AIRWORTHINESS DIRECTIVE GLIDERS

GFA AD/129 L.E.T. KUNOVICE 16

L-13 Blanik all serial numbers (Mandatory Bulletin No. L13/052 refers)

"P"

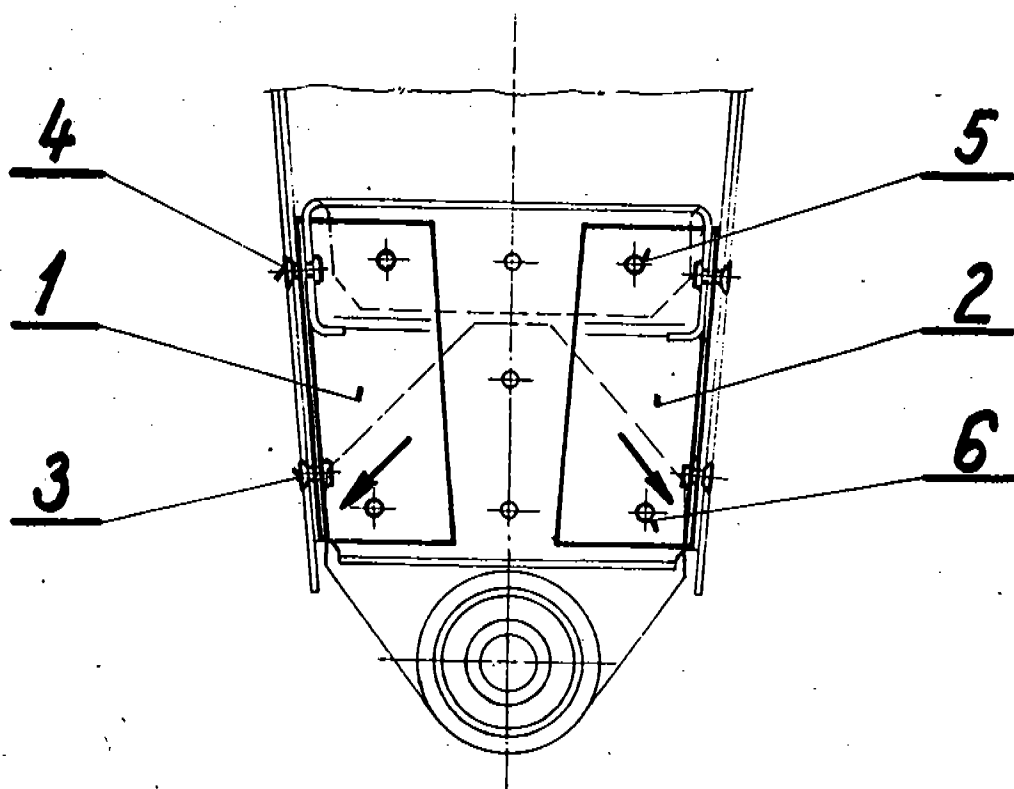
- 2) Carefully drill off original rivets pos. 3 and 5 using a 2.6 mm dia. drill and rivets pos. 4 and 6 using a 3 mm dia. drill. See Fig 1, view "P".
- 3) Drill holes at the ends of cracks using a 2 mm dia. drill and de-burr the holes carefully.

- 4) Locate angle pieces pos. 1 and 2 on the rib - see Fig. 1, view "P". Through original rivet holes mark-off and centre-punch holes on angle pieces. Drill holes dia 3.1 mm for rivets pos. 4, 5 and 6. Holes for rivets pos. 3 to be drilled using a 2.7 mm dia. drill and dimpled. Re-drill holes for rivets pos. 5 in the spar boom to the diameter of 3.1 mm.

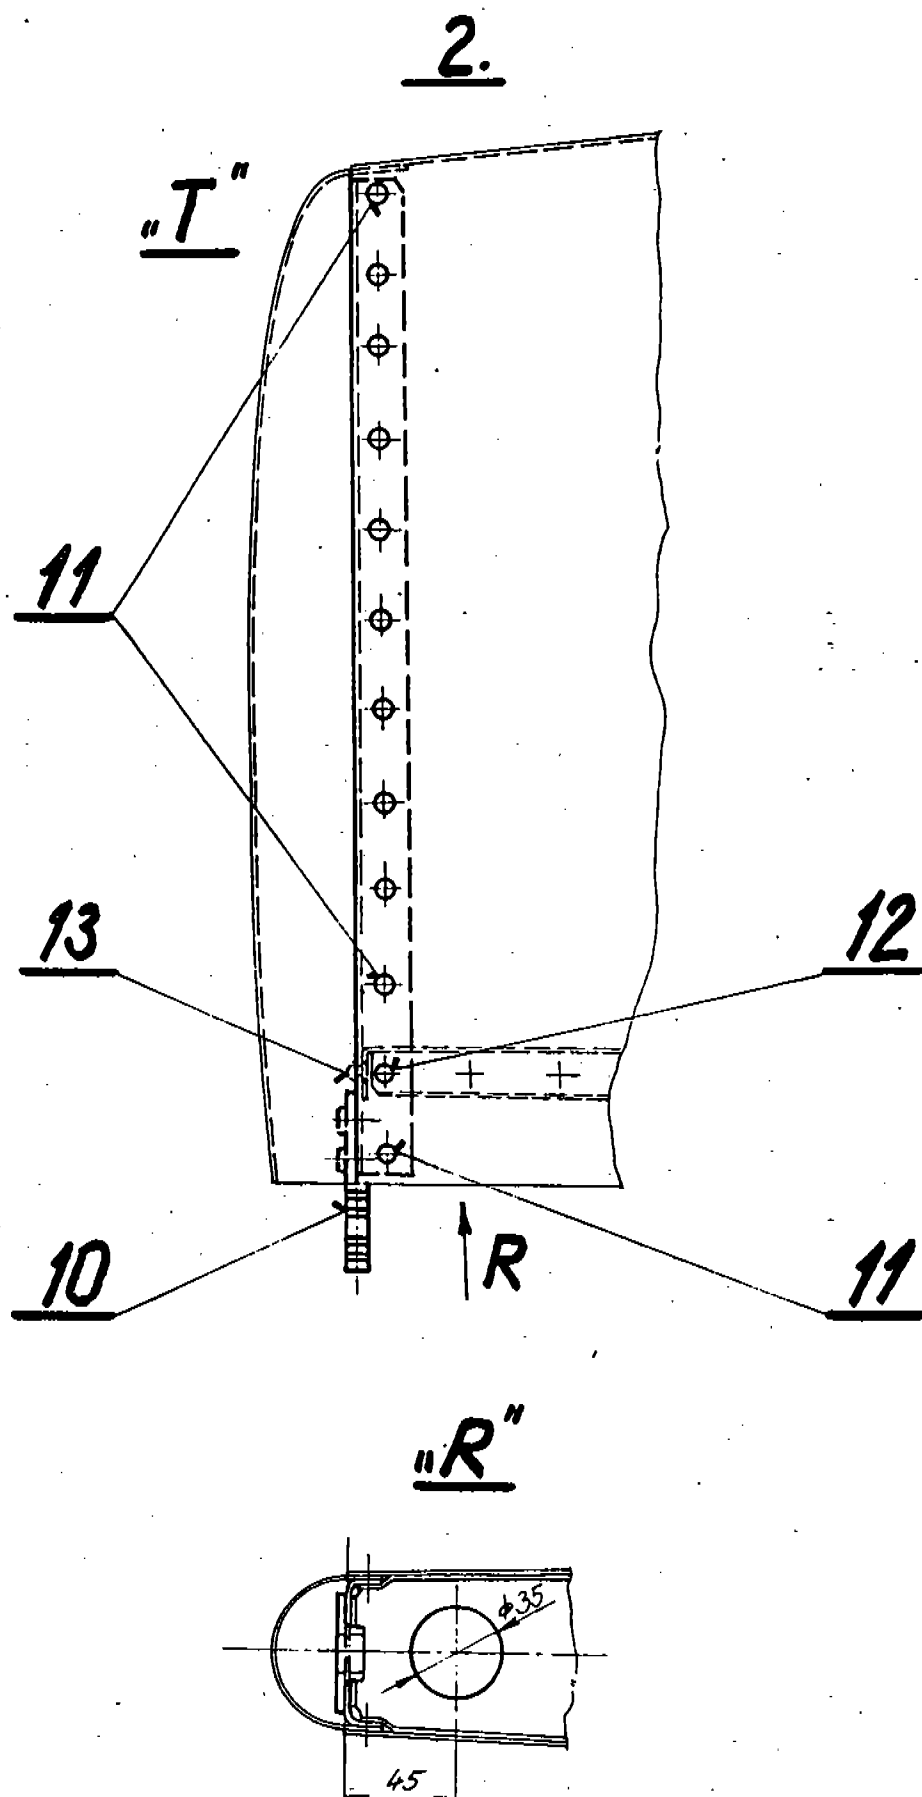
- 3) Carefully drill off original rivets pos. 11 using a 2.6 mm dia. drill and rivets pos. 12 using a 3 mm dia. drill. See Fig. 2, view "T" (from Fig. 1.).

- 4) Remove tip piece.
- 5) Drill off three rivets pos. 13 fastening end rib to the spar using a 2.6 mm dia. drill. Remove end rib.
- 6) Make a 35 mm dia. hole in the spar and deburr carefully. See Fig. 2, view "R".

- 7) Install new end rib pos. 10 in the tailplane. Through original rivet holes in the spar mark-off and centre-punch roles for rivets pos. 13 on end rib.
Drill holes using a 2.7 mm dia. drill. Fasten end rib to the spar using e.g. two bolts.
M2. Reinstall tip piece and check the distance between hinge attachments (as marked-off before removing the original and rib). Through original rivet holes drill 2.7 mm dia. holes for rivets pos. 11 and 3.1 mm dia. holes for rivets pos. 12 in the end rib. It is necessary to keep the distance of 7 mm minimum between rivet holes and the edge of rib flange.

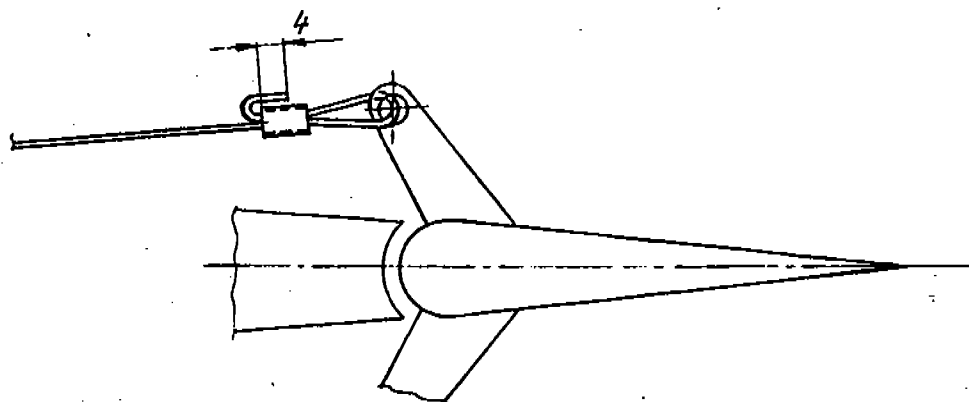
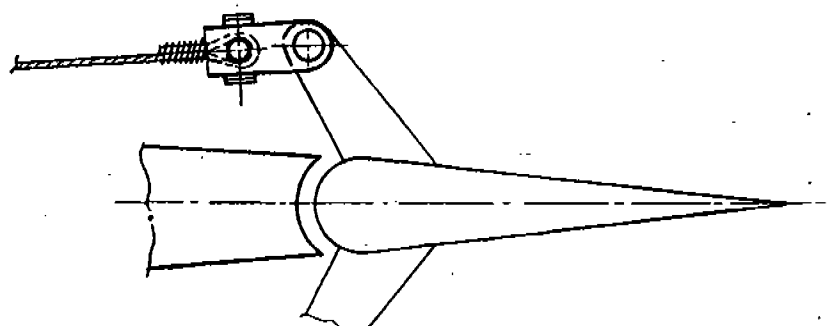
- Stretch wires (cables) by hand by pulling on their ends and fix them to the levers on trim tabs.
Typical connection of wires is shown on Fig. 3, connection of cables on Fig. 4.
- Tie the ends of cable with locking wire and solder.
- Adjust trim tab deflections to $12^{\circ} \pm 1^{\circ}$ up and $35^{\circ} \pm 1^{\circ}$ down by means of turn-buckles between frames No. 14 and 15.
- Stretch the whole control cable system, if necessary, by means of turnbuckles at trim tab rear lever in the cockpit.
- Reinstall upholstered side section.

5.SK-L13. 276-01SK-L13. 276-02

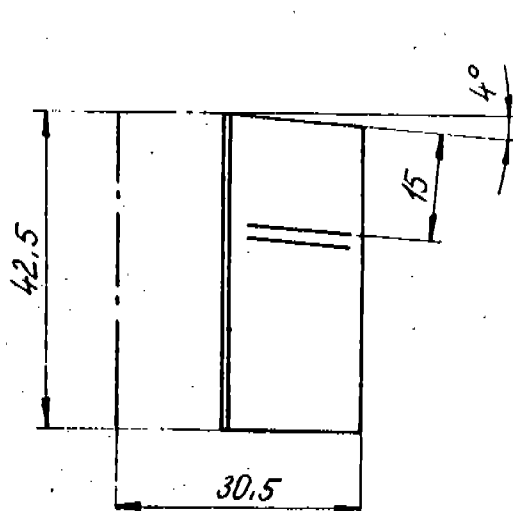
Angle pieces pos. 1 and 2 can also be workshop - made according to Fig 5.
